Packet Guide

BAR 21-02-01

511 East Water Street

BAR 21-01-05

Illustrative porch detail for 116 West Jefferson Street: Dimensions and proportions should match or be similar to 406 Altamont Circle and/or appropriate to the period. The BAR should discuss specific dimensions, if necessary.

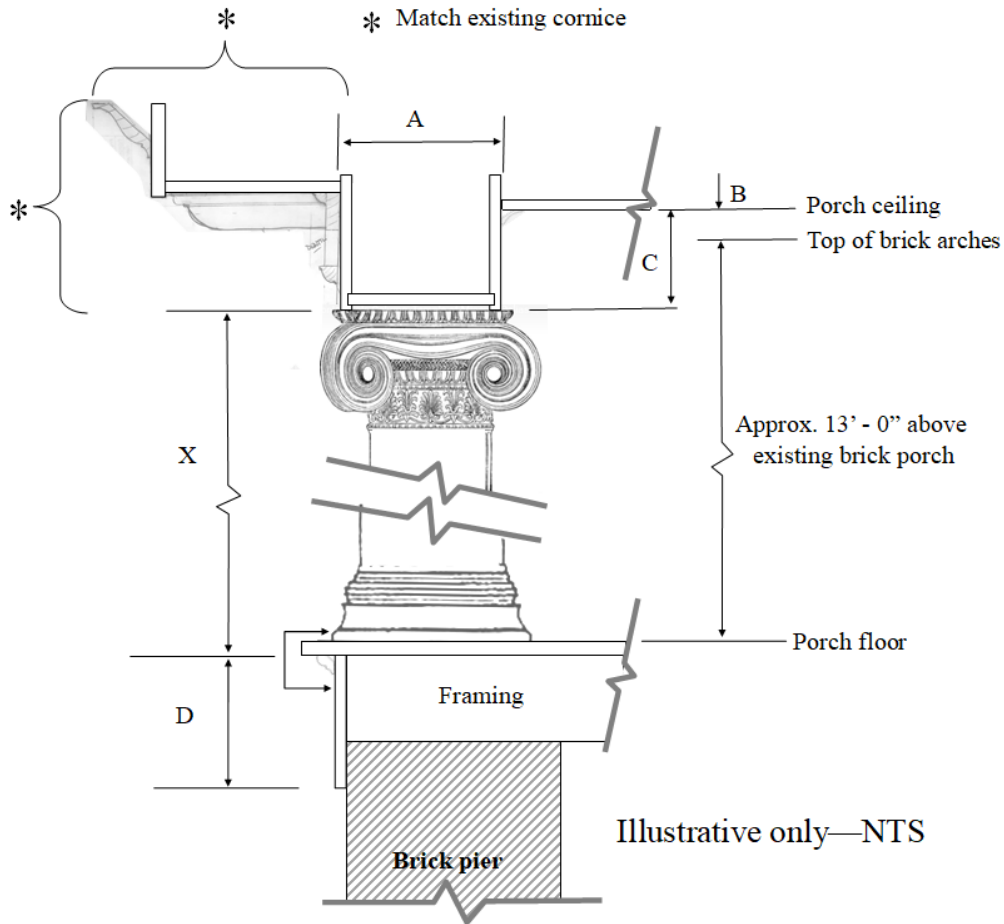
Railing to match or be similar to railings at 406 Altamont Circle.

Revised detail 4 on Sheet A-3

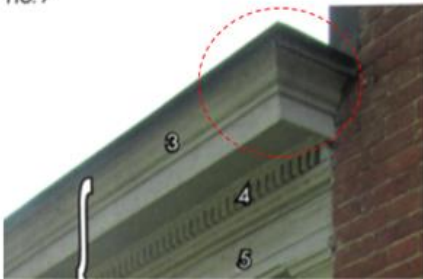
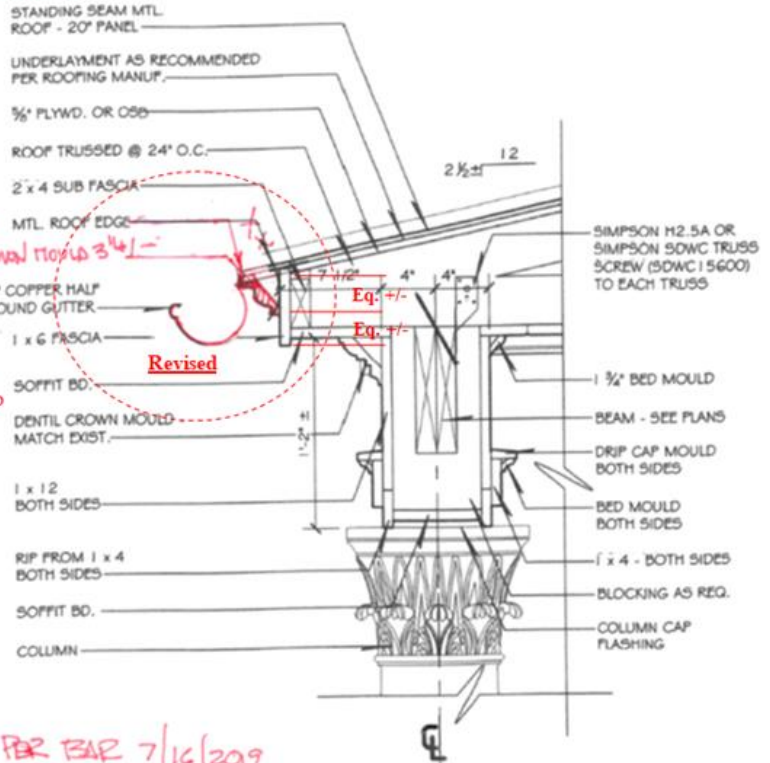
Add simple crown mould, similar profile and proportions to that shown in Fig 7 of the July 2019 BAR submittal (below). Available, stock profile is fine.

LANDSCAPE PLAN
612 WEST MAIN STREET

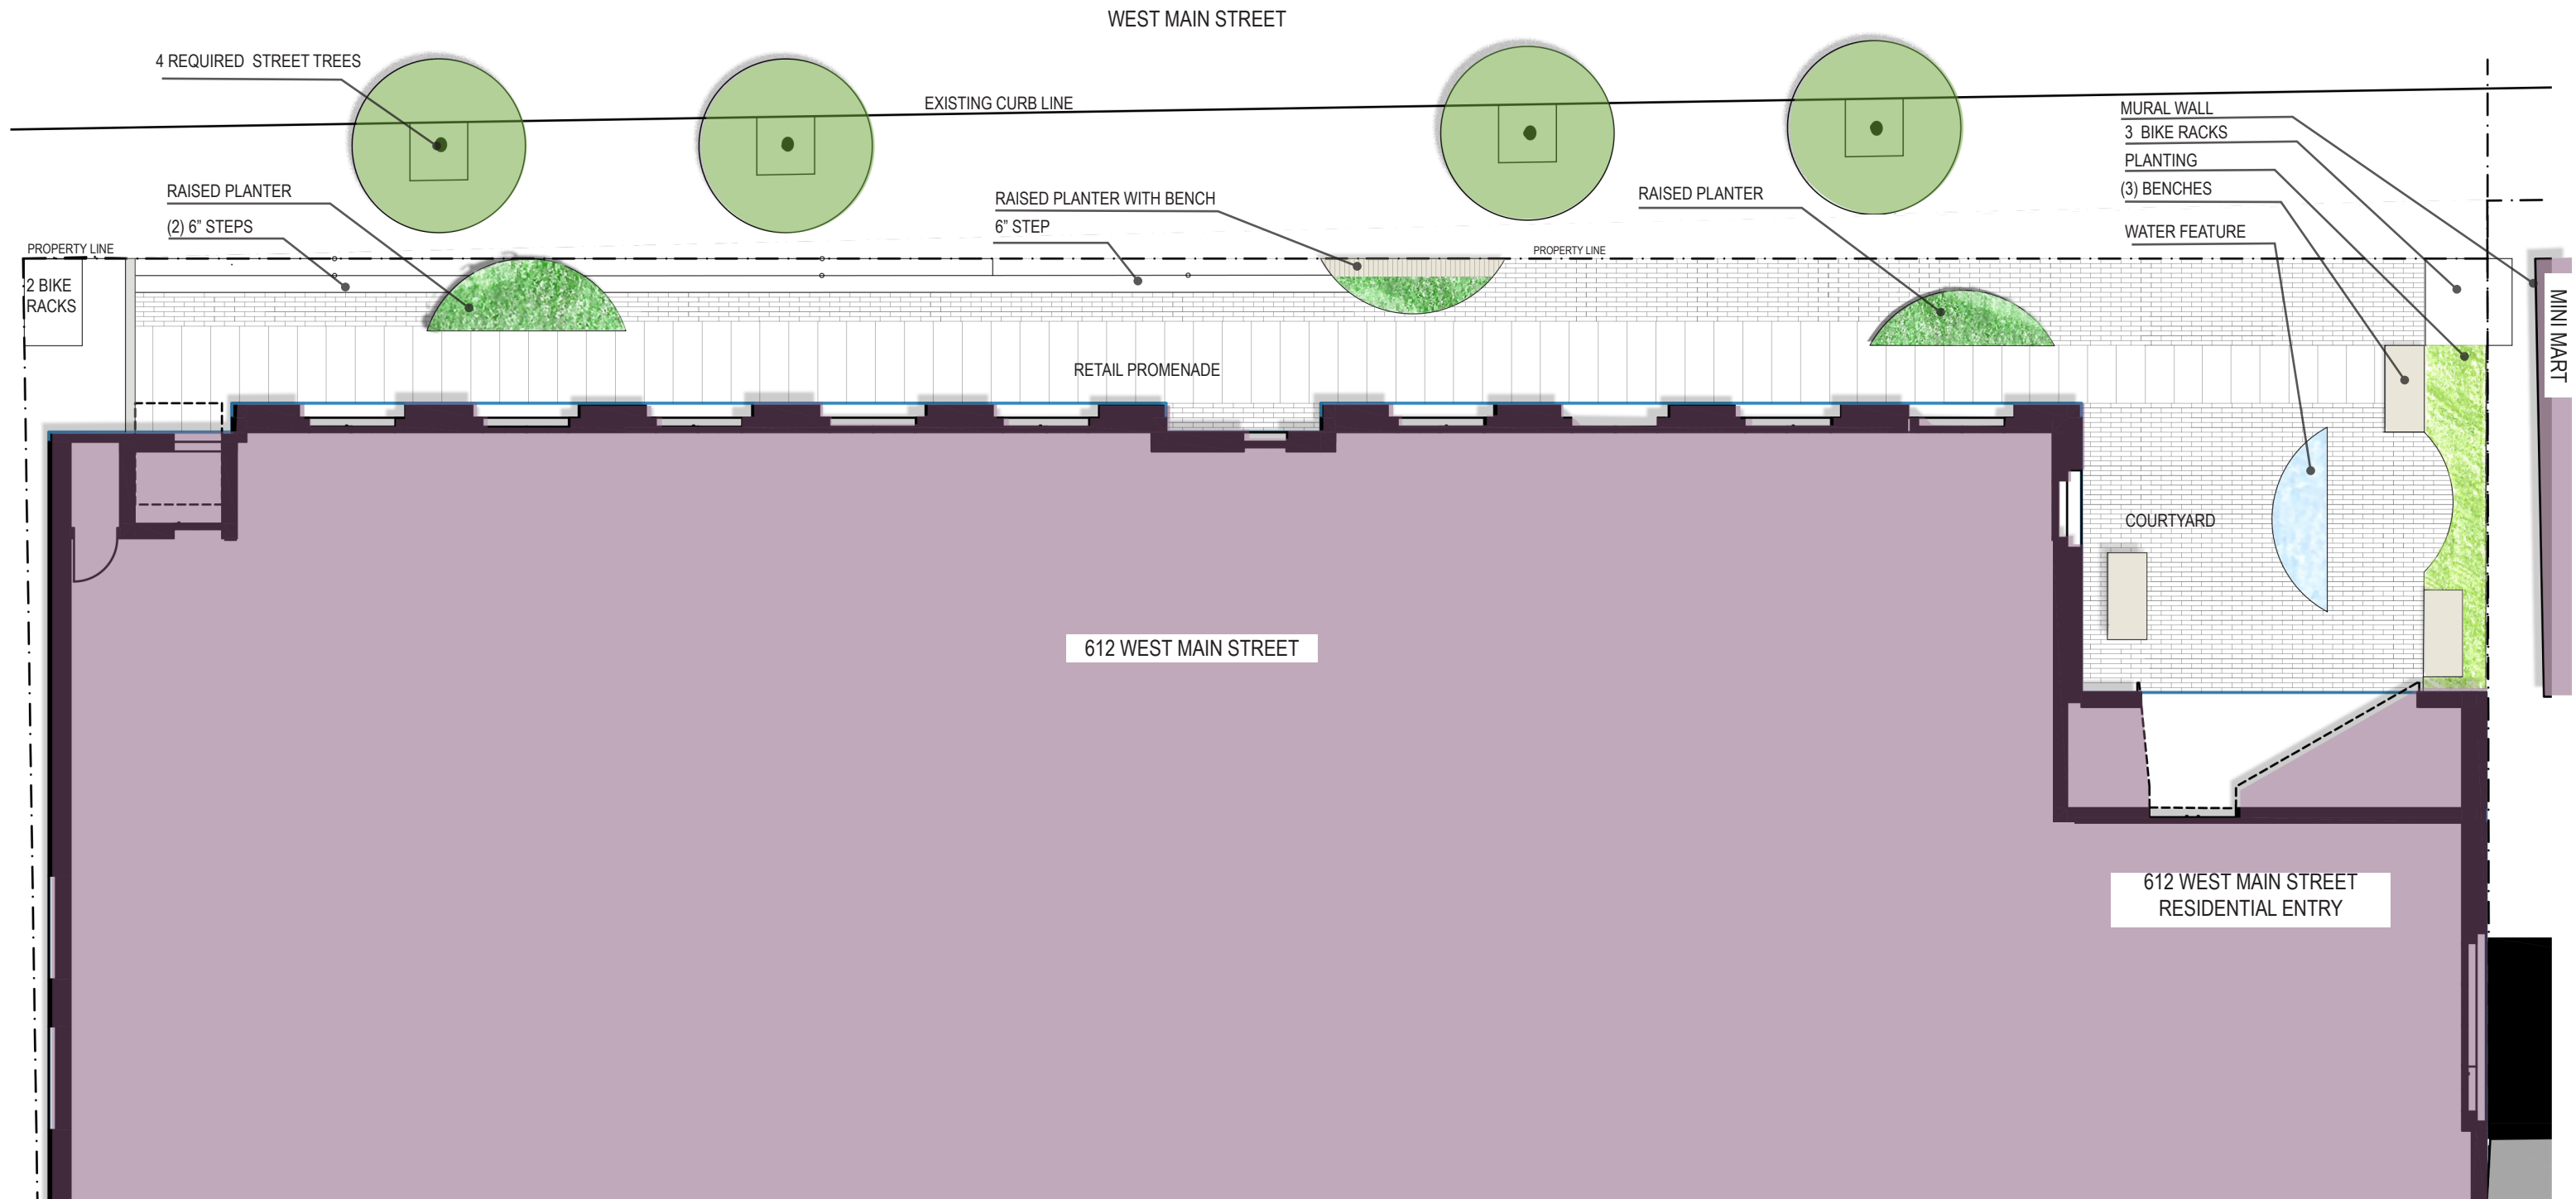
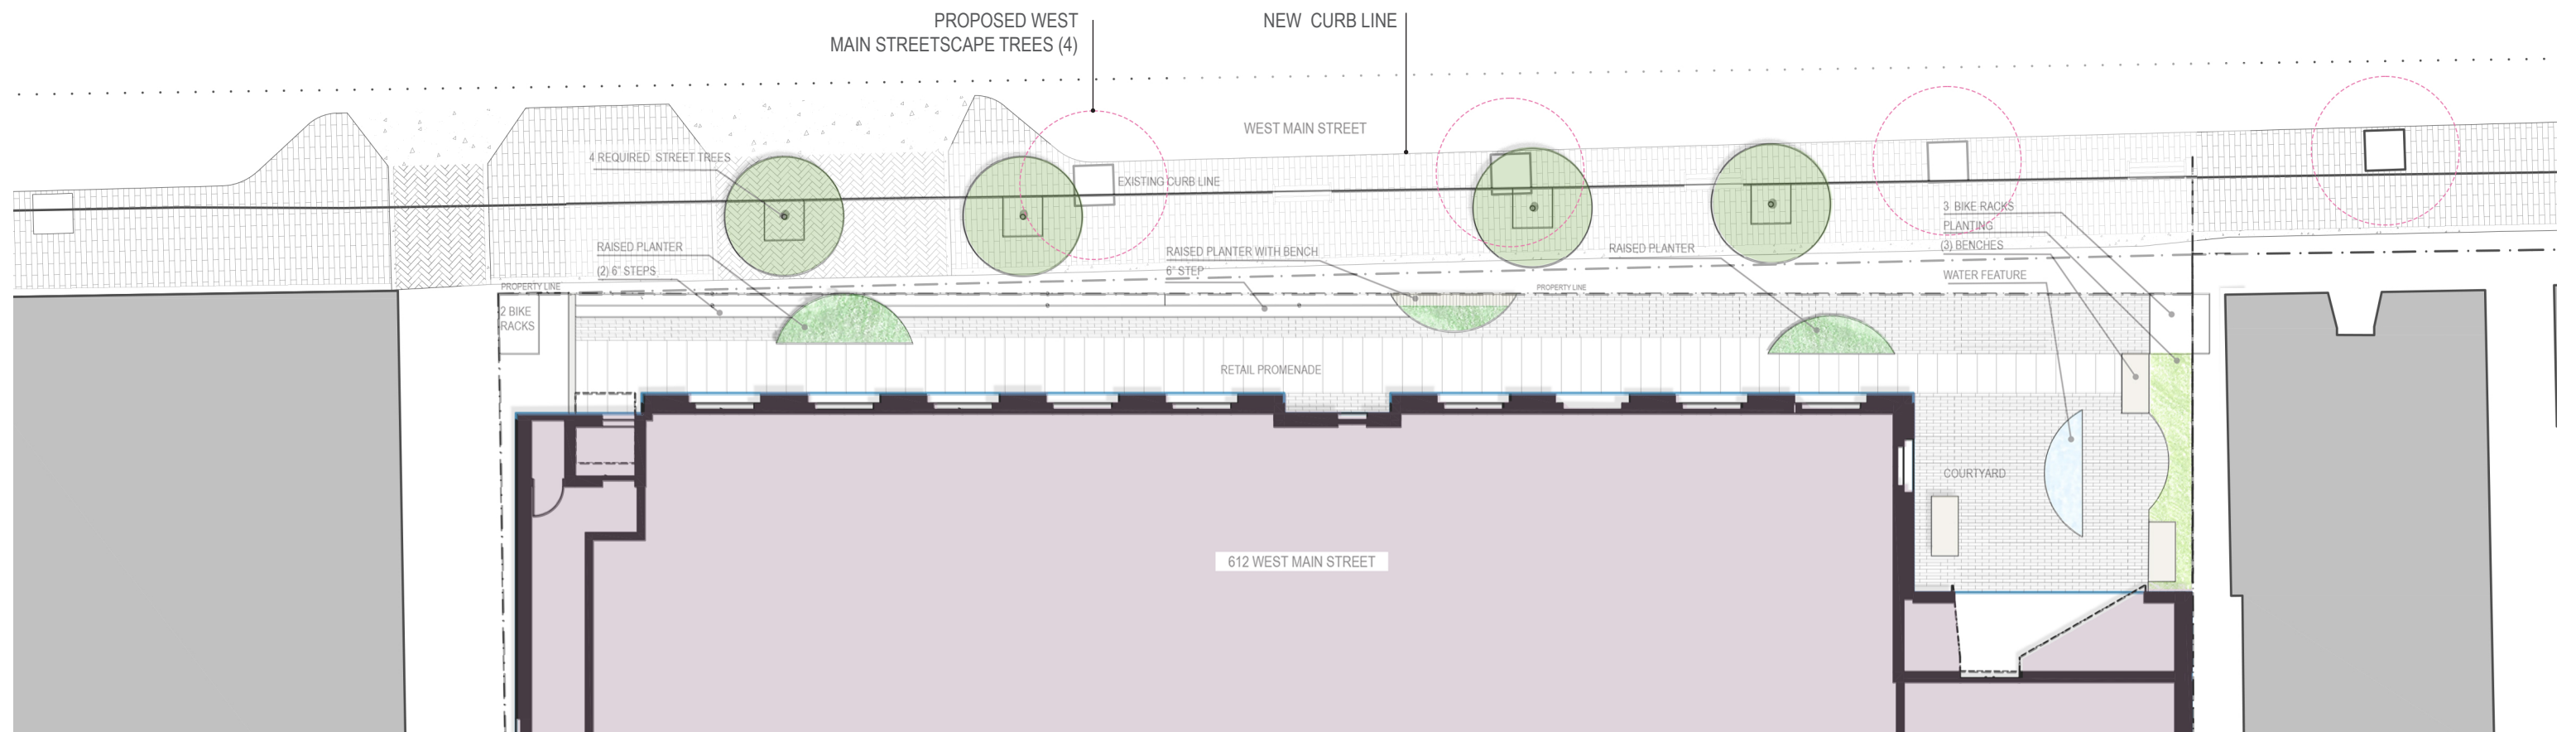
- Comments in regards to the proportion of planting relative to the building and the street/ public zone.
- We are in a gray area with the new curb alignments proposed in the West Main Streetscape plan. We are required (4) trees for the 612 building frontage, regardless, and will be planning to place these. Can the focus of the discussion look to the placement of these project specific trees? Does the BAR feel we need to take further steps with the WMS plan?

STREET ELEVATION

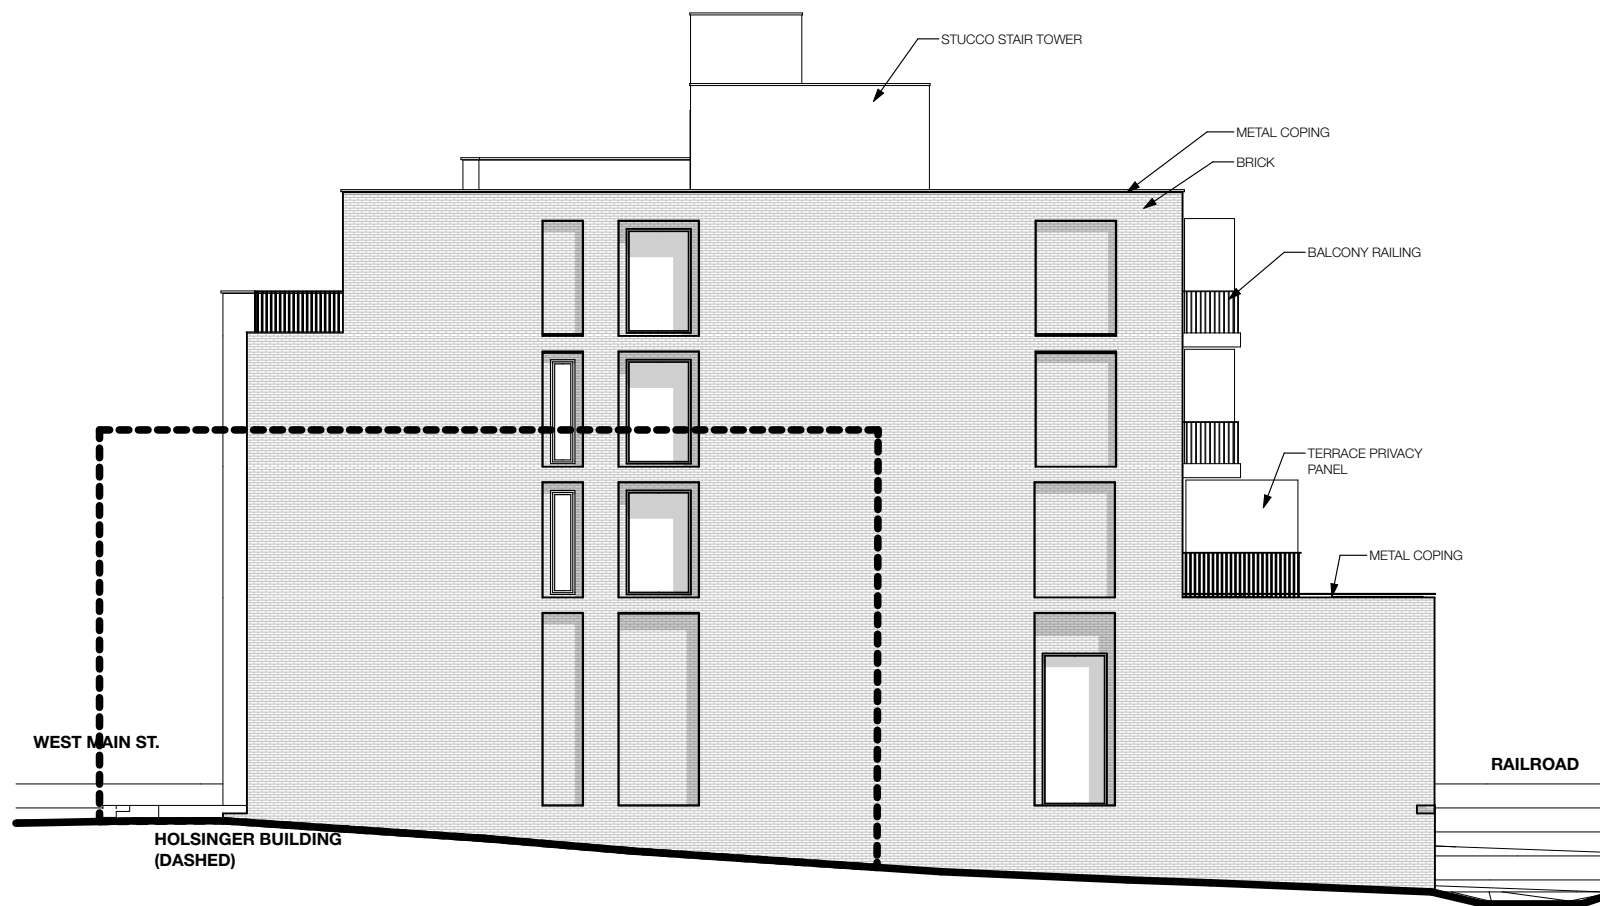
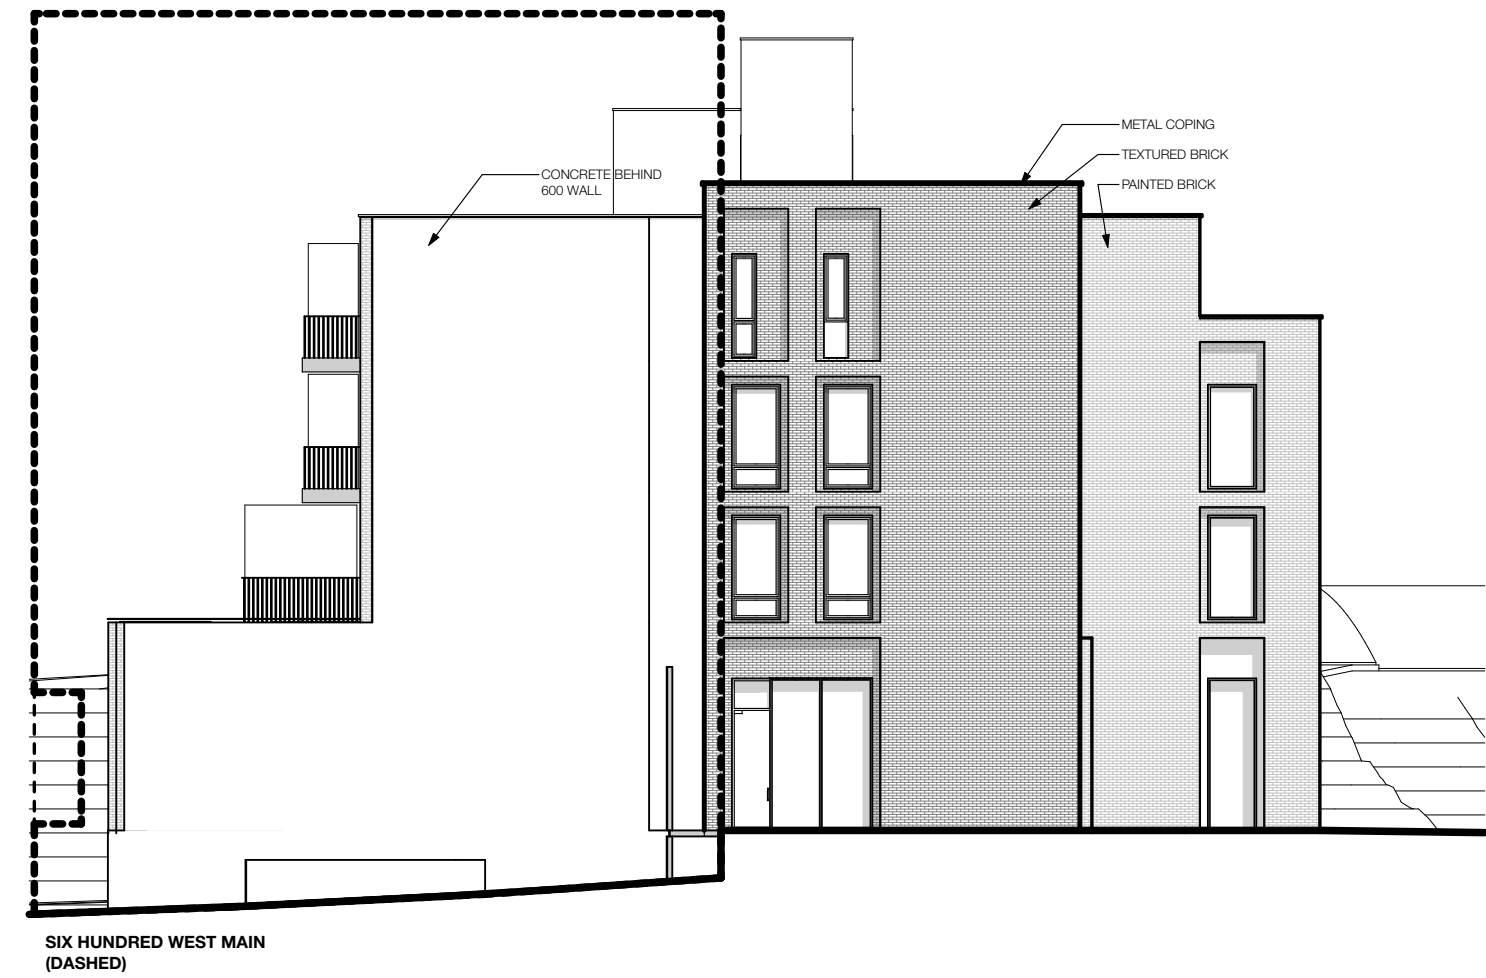
- The north (West Main Street) elevation has not changed greatly from the previous discussion when the BAR found its development to be approvable. We will continue to refine it in the months ahead.
- We would appreciate any comments regarding the south and west elevations.
- The north, west and east elevations will be all brick. For cost reasons, we propose the south elevation as mostly stucco, bounded by brick at the east and west corners. This is a similar treatment to the south facade as at 600 West Main Street (stucco facade bounded by metal panels on the east and west corners). Will the BAR approve such a change of material on the rear facade?
